TECHNICAL REVIEW
ON THE
SITE CHARACTERIZATION REPORT (SCR)
FOR THE
BASALT WASTE ISOLATION PROJECT (BWIP)

Final Report
April 15, 1983

Prepared by
GOLDER ASSOCIATES
W. Roberds
J. Voss (Consultant)
D. Pentz

Prepared for
STATE OF WASHINGTON
Energy Facility Site Evaluation Council
High-Level Nuclear Waste Management Task Force

STRATIGRAPHY OF THE REFERENCE REPOSITORY LOCATION

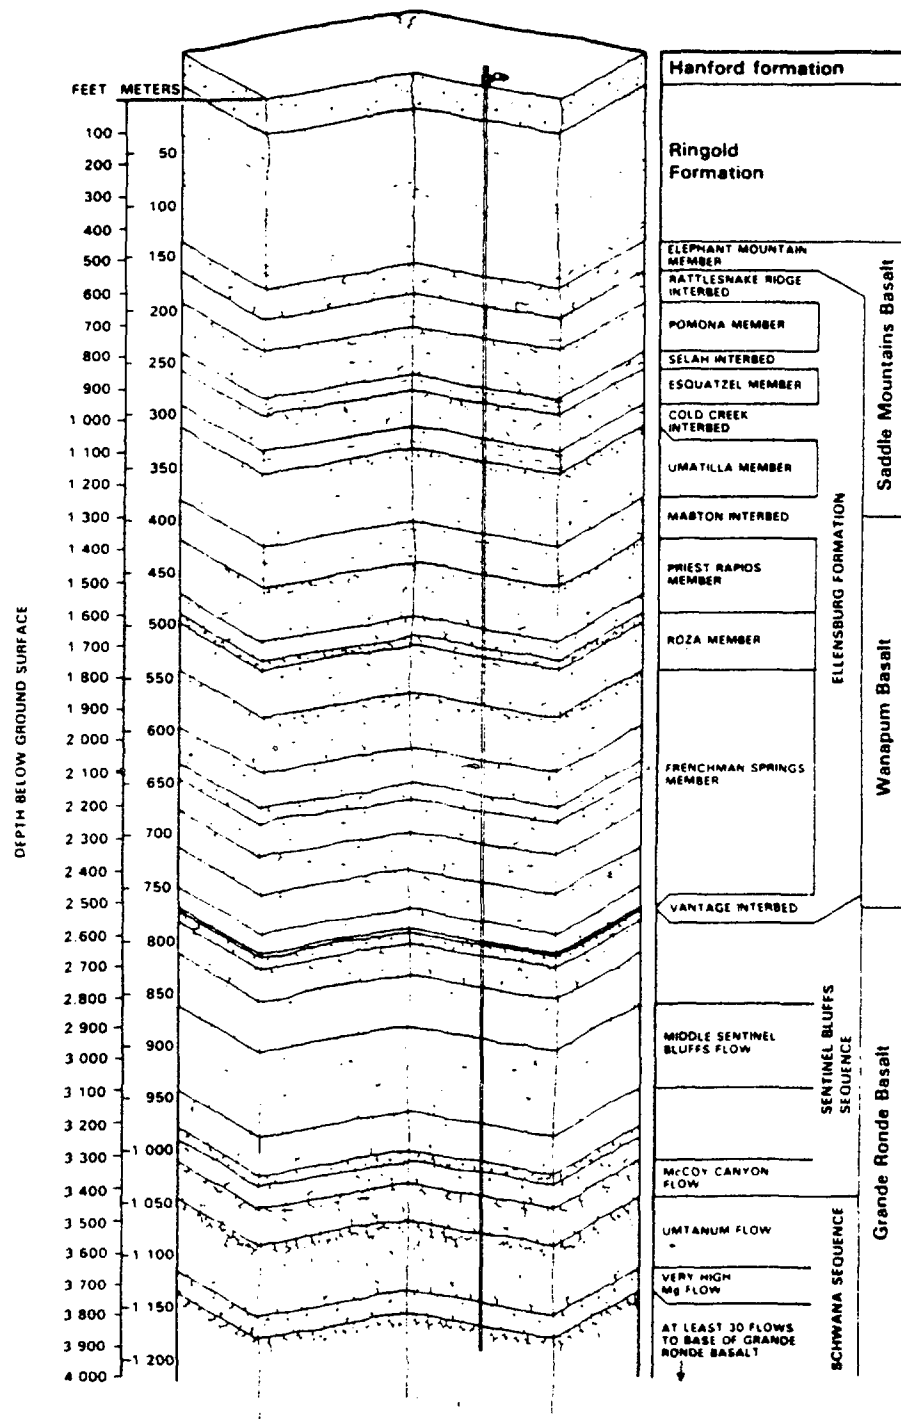
- ADEQUATE INITIAL DATA BASE EXCEPT FOR INTRAFLOW VARIABILITY
- SUITABLE DATA BASE INTERPRETATION

HYDROGEOLOGIC BOUNDARIES

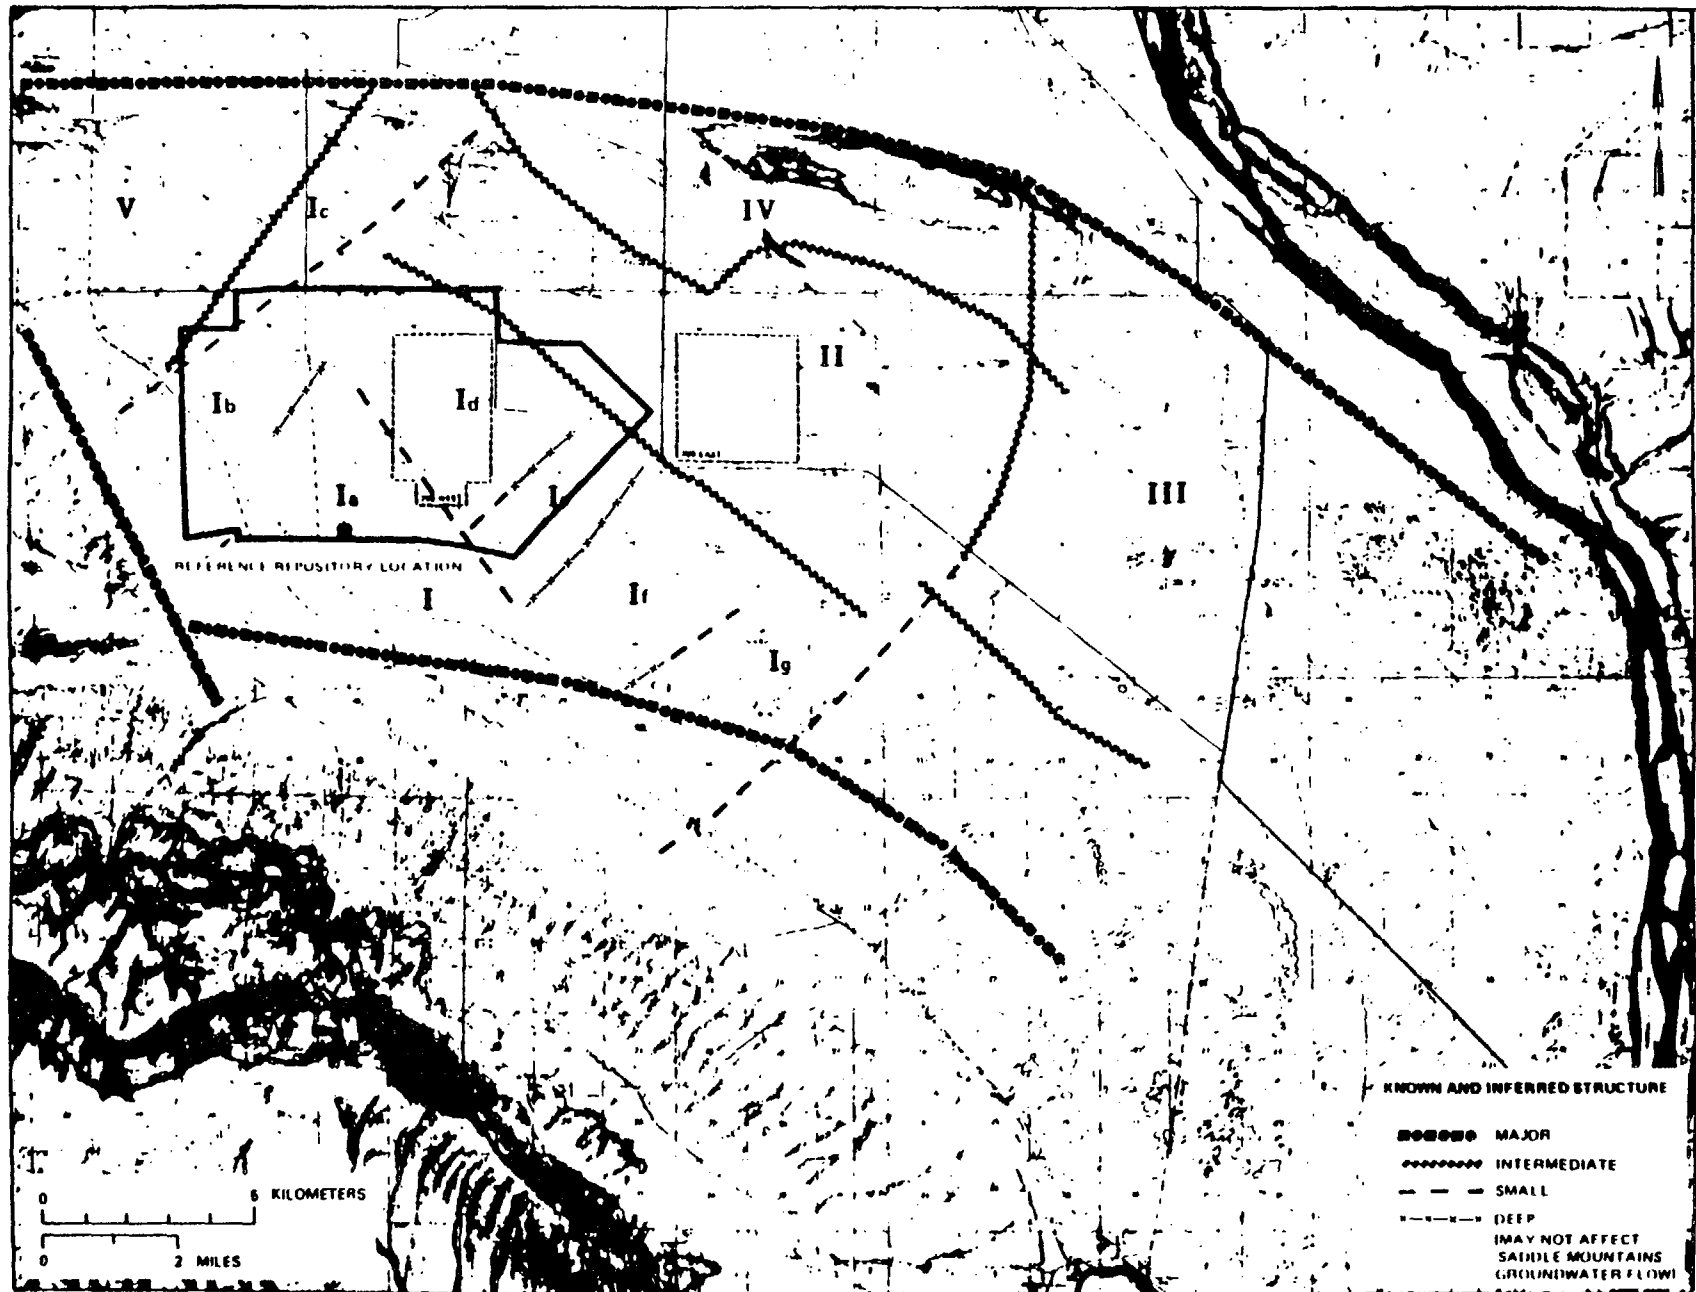
- HYDRAULIC PARAMETERS
- HYDRAULIC HEAD
- NO DATA ON HYDROGEOLOGIC BOUNDARIES

REPOSITORY CUTAWAY

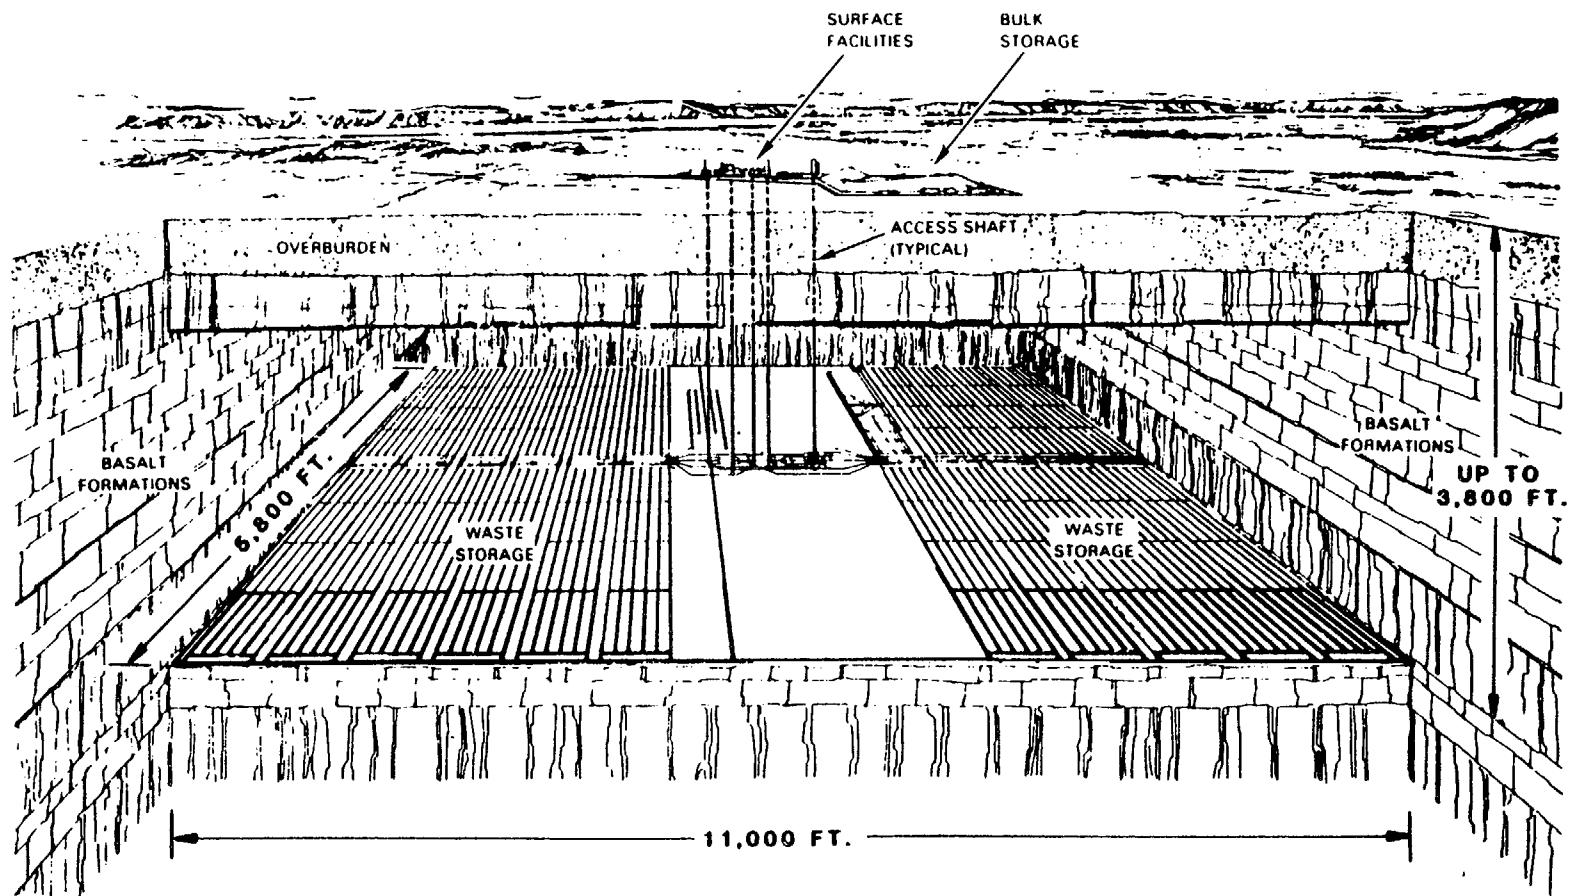
- DESIGN DESCRIPTION SUFFICIENT EXCEPT
 - UNDERGROUND OPENINGS
 - DESIGN PROCESS UNDEFINED, E.G., DESIGN CONTINGENCIES, THICKNESS VARIATIONS
 - DESIGN OF ENGINEERED BARRIERS
 - RETRIEVAL ASSESSMENT
- PERFORMANCE AND DESIGN CONFIRMATION DETAILS LACKING
- IN SITU TESTING PLANS ARE POTENTIALLY INCOMPLETE
